SWSP Approval for the East Rigden Pit (Plan ID 3055)

July 1, 2022

Re: City of Fort Collins East Rigden Pit Substitute Water Supply Plan (WDID 0302570, Plan ID 3055)

DRMS Permit No. M-1979-097 (WDID 0303021)

Attachments: Figure 1

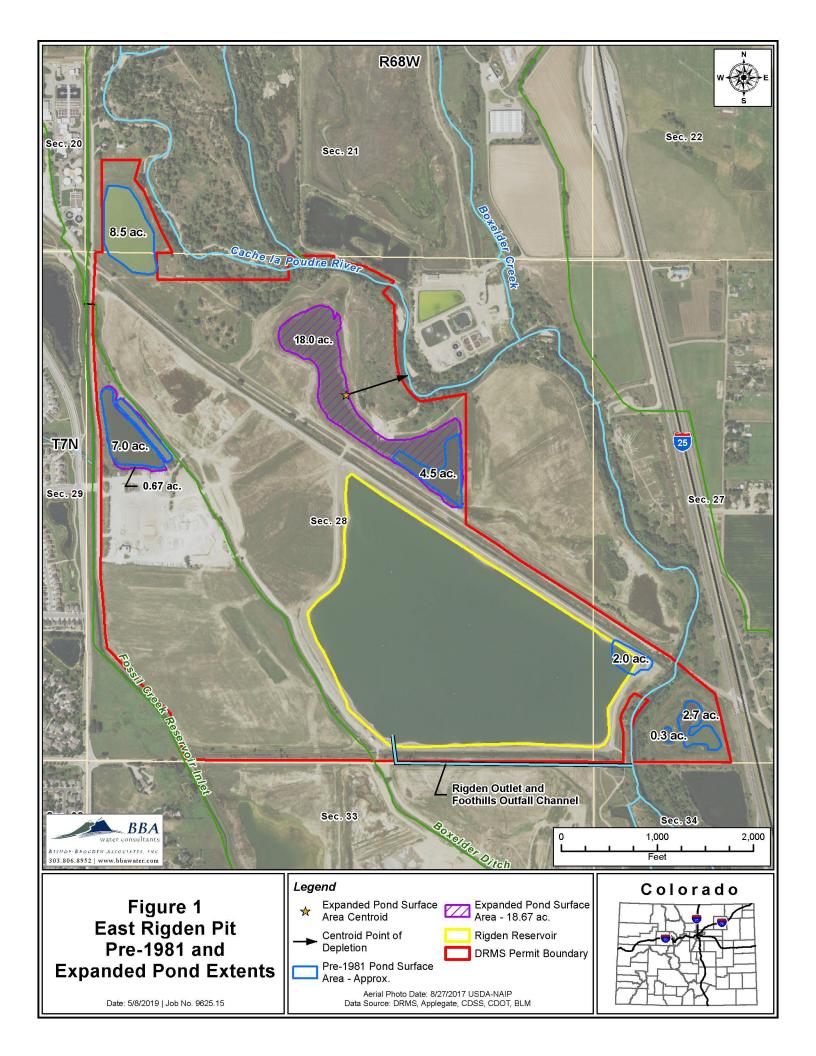
The East Rigden Pit is located south of the Cache la Poudre River in Sections 21, 27, and 28, Township 7 North, Range 68 West of the 6^{th} P.M., as shown on the attached Figure 1. Past sand and gravel mining operations exposed groundwater at the East Rigden Pit, but the site has not been mined in many years.

gravel pit boundary. The pre-81 areas of groundwater exposure as documented in the May 17, 2011 SWSP Approval are shown in blue on the attached Figure 1.

A compacted clay liner was constructed around the portion of the East Rigden Pit shown in yellow on the attached Figure 1 in September 2014. The liner was approved by the State Engineer's Office as meeting the design standard for liners on May 20, 2015, and classified as a lined reservoir in accordance with the August 1999 State Engineer Guidelines for Lining Criteria for Gravel Pits (Rigden Storage Reservoir, WDID 0303326). The February 27, 2015 SWSP Approval stated that upon approval of the compacted clay liner, no depletions associated with the East Rigden Pit would remain after the conclusion of that plan period and no subsequent SWSP was anticipated to be required for the site, due to all areas of groundwater exposure at that time either being within the lined area or within the 25 acres documented as having been exposed to the atmosphere prior to January 1, 1981.

A DRMS field inspection in January 2019 found that the acreage of the exposed groundwater had increased beyond the pre-81 extent. This additional exposed surface area is considered to have been exposed after December 31, 1980 ("post-80") and has been included in a substitute water supply plan since July 1, 2019. Fort Collins does not plan to conduct any mining activities during the term of this SWSP, therefore the only consumptive use of water at the East Rigden Pit will consist of evaporation from these additional areas of exposed groundwater.
